NAVAL BIODYNAMICS LABORATORY
NBDL-91R003

HUMAN FACTORS ASSESSMENT OF USCG 47-FT MOTOR LIFEBOAT

Technical Report

I: Preliminary Evaluation of Ergonomic and Safety Deficiencies

Figure I.3. Watertight door with control wheel, extended handle, and dogs.

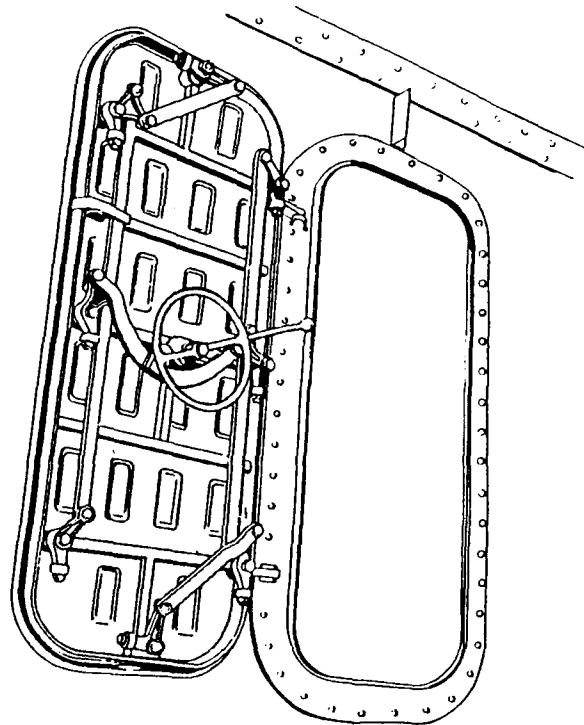
- The door impedes the movement of the port OB chair.
 - The bolts of the door are exposed and present a hazard to the crew passing through the door. Crewmembers have reported minor injuries due to these bolts.

- Approach:**
- The door should be designed with a self-locking mechanism to secure the door in an open position. This mechanism is recommended for all doors.

- All dogs are operated at once by the extended handle located on the control wheel of the watertight door. The handle will provide positive control for the crew (see Figure I.3).

Figure II.1a. Current starboard steering station on open bridge.

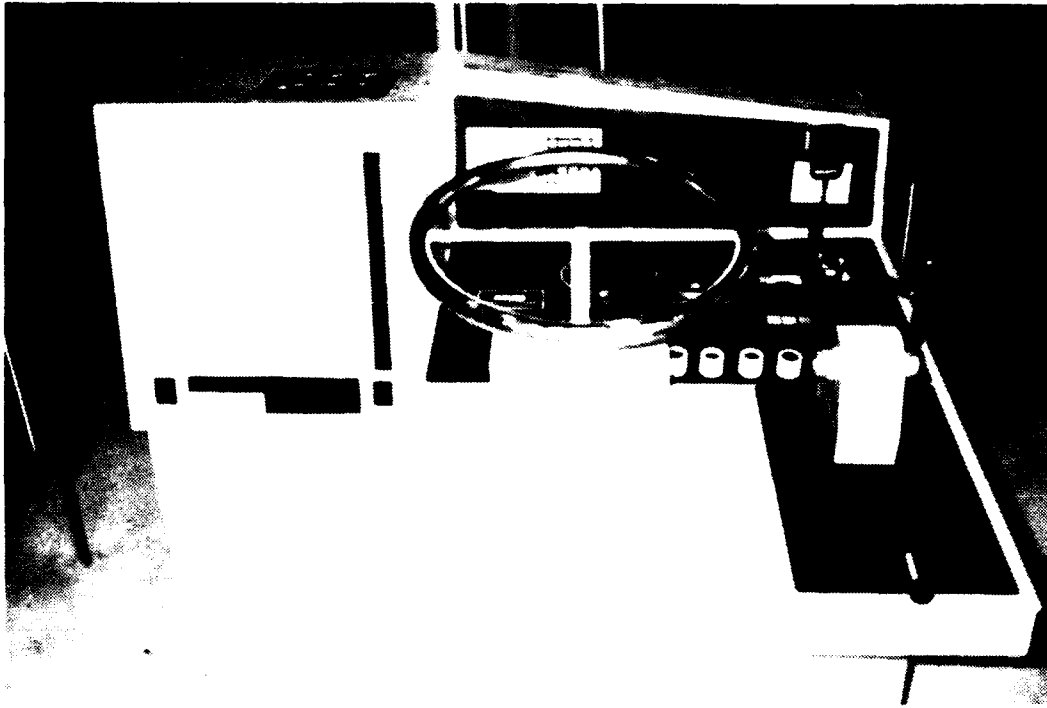
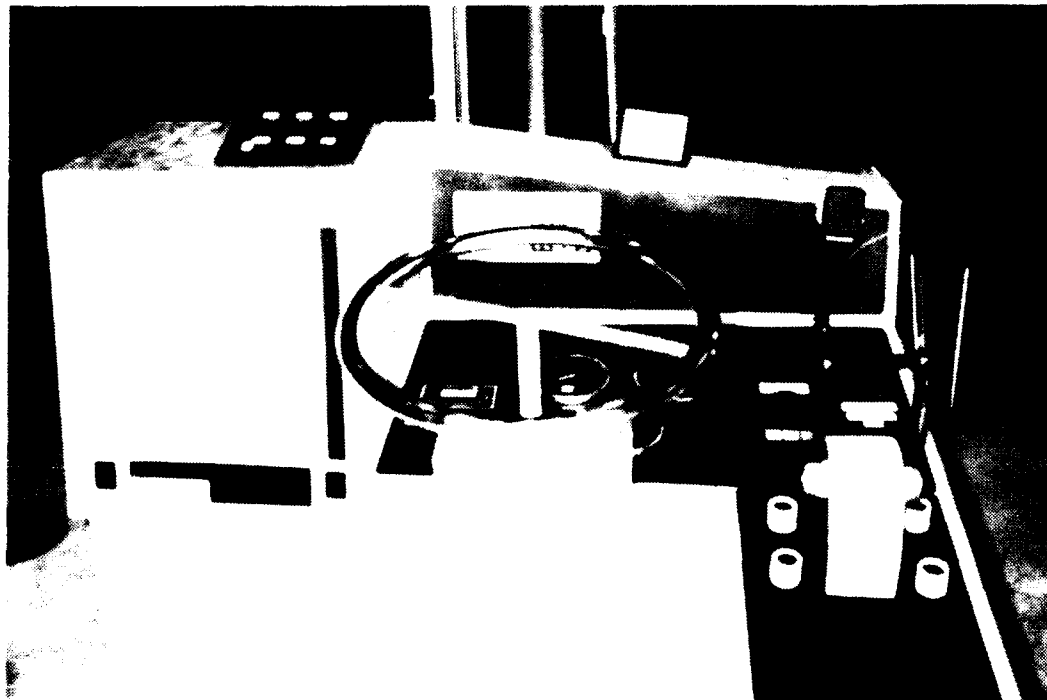
Figure II.1a represents the current layout of the starboard console on the open bridge. The layout of the starboard console (primary steering station) provides both a steering wheel and a backup jog lever steering control.

- Problem:**
- All controls and displays viewed and controlled by the operator are not clearly visible from the normal operating position (seated). In

- In place of two microphones, use a single microphone and selector switch to reduce the viewing obstruction to the control and displays. The switch should be located in close proximity to the microphone (see Figure II.1b).

Figure II.11. Wide angle view of enclosed bridge.

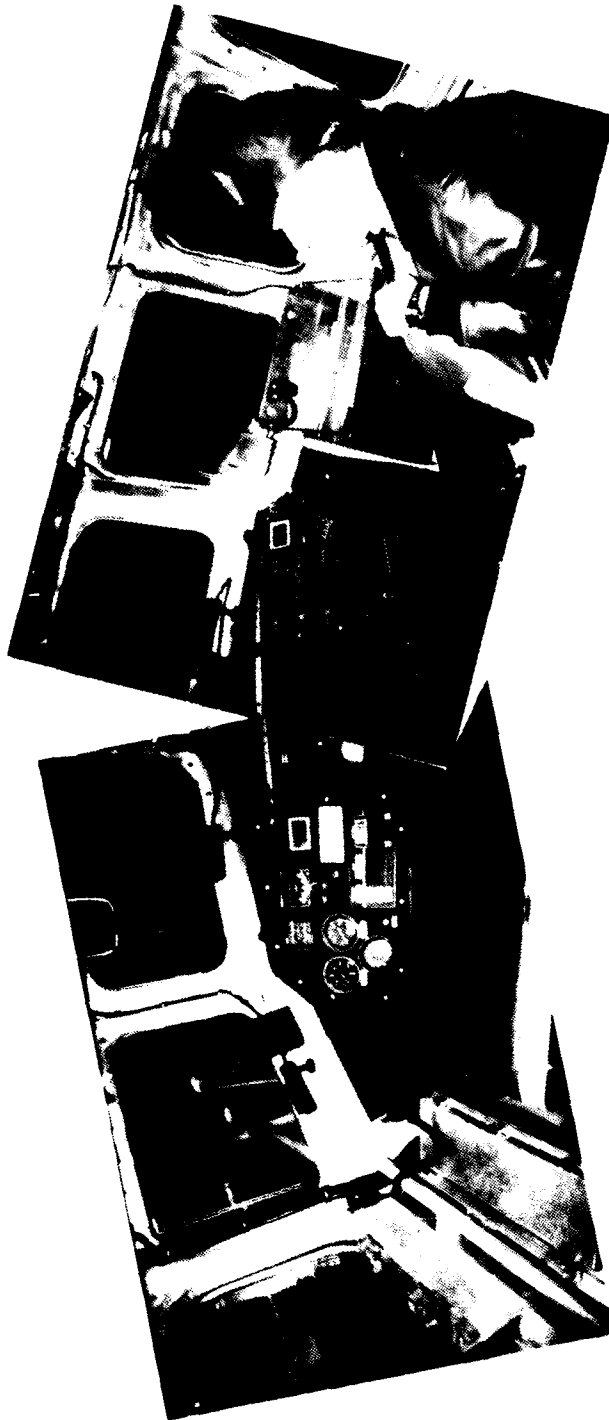
The appearance of the steering stations seems to indicate that the existing layout of controls and displays was based primarily on space considerations, placing equipment where it would fit (see Figure II.11). A more organized arrangement is possible. However, the current layout due to the constraints of the boat may not follow optimal human factors engineering fundamental guidelines, but should be adequate.

Figure II.20. Wet compass and window wiper controls.

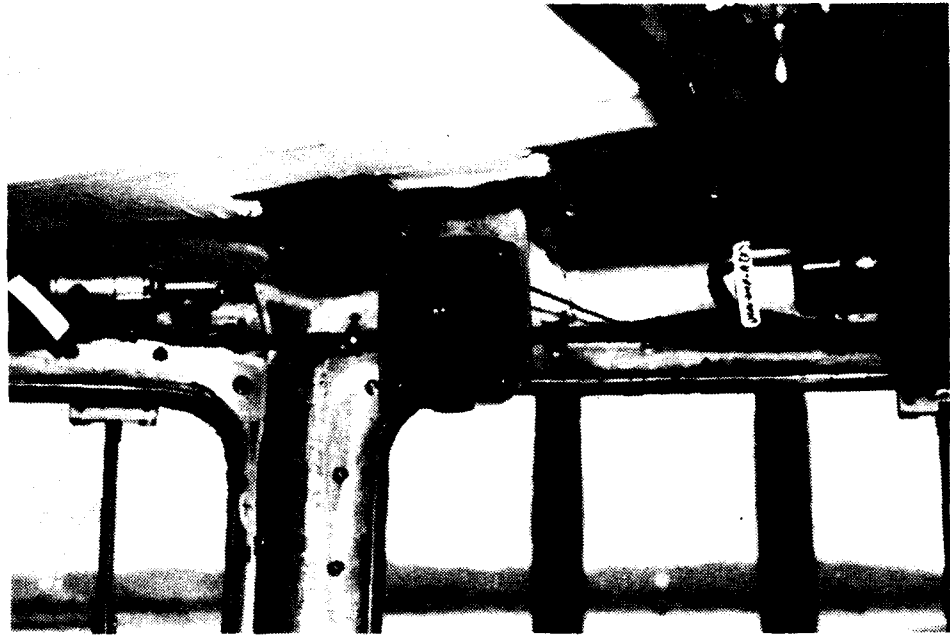
- Arrange the gauges in a similar manner in both open and enclosed bridges (see Figures II.5 and II.12).
 - Wet compass in the enclosed bridge: This compass is attached to the overhead above the port operator's position (see Figure II.20). Normally, to steer a heading, one lines up the compass lubber line with the desired course degree heading of the compass. The helmsman and lubber line are normally in parallel alignment with the boat's longitudinal axis.

Figure II.22. Window/heaters junction box in enclosed bridge overhead.

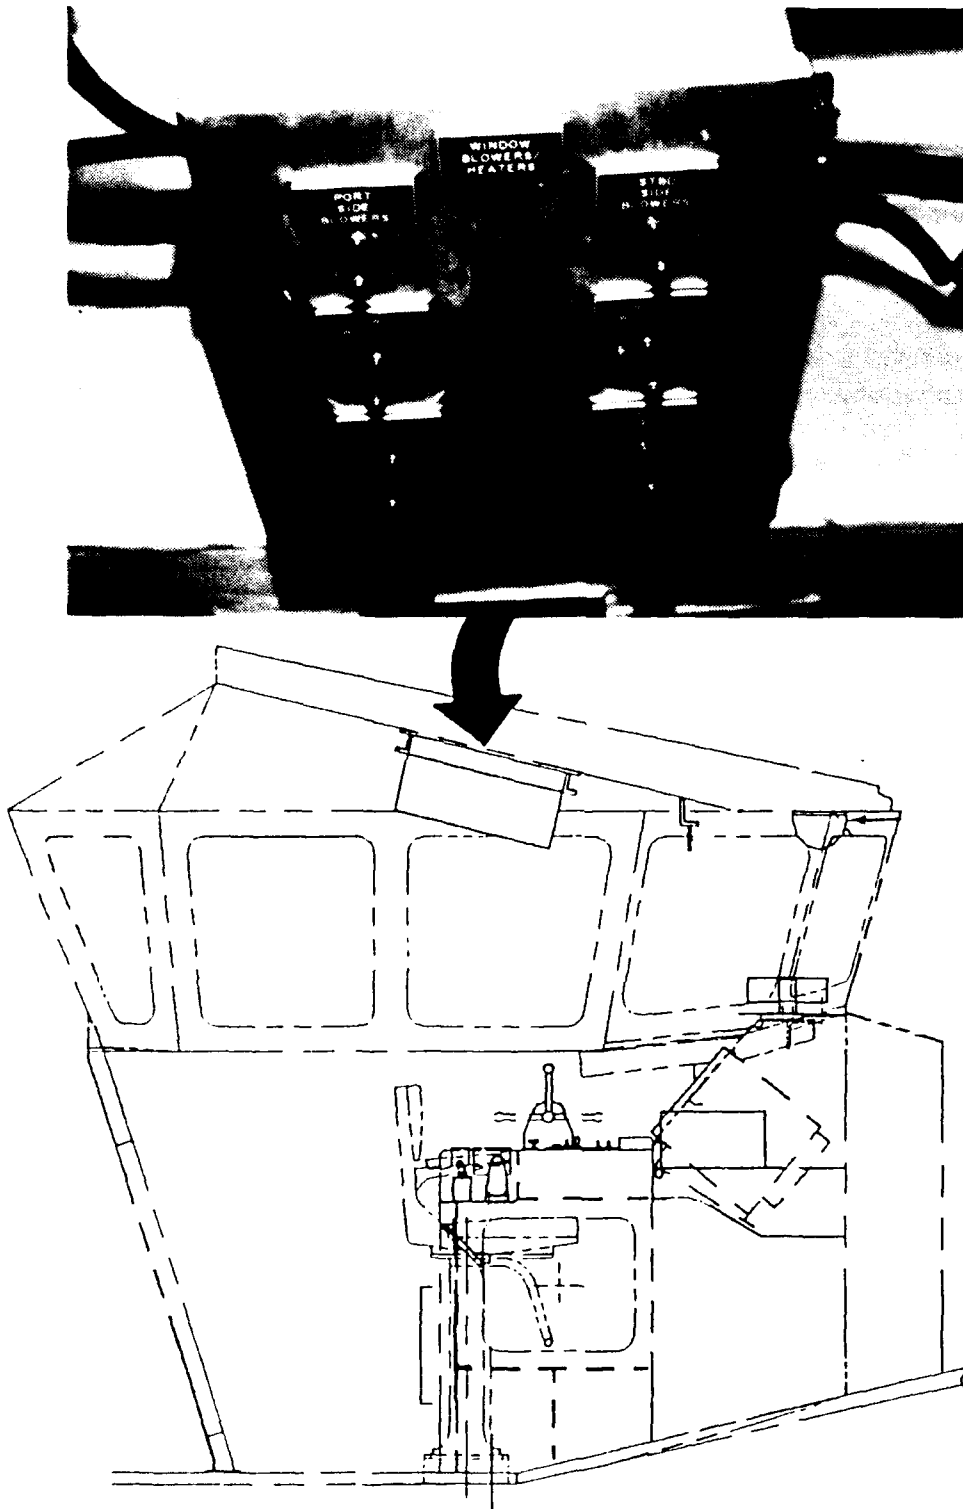
The window blower/heater switch panel is mounted on the overhead at the centerline and between the two forward seats (see Figure II.22). The window washer button is located on the dashboard in front of the portside chair. The window wiper control panel is located directly aft of the radar plotter keyboard.

- Group windshield cleaning controls together on the forward dashboard or in the overhead.
- To increase the visibility of the operator an additional window in the hatch door to the open bridge may be installed. As an alternative, the current window can be enlarged. In both cases the operator would have a wider view of the open bridge and aft of the boat, particularly during towing operations.
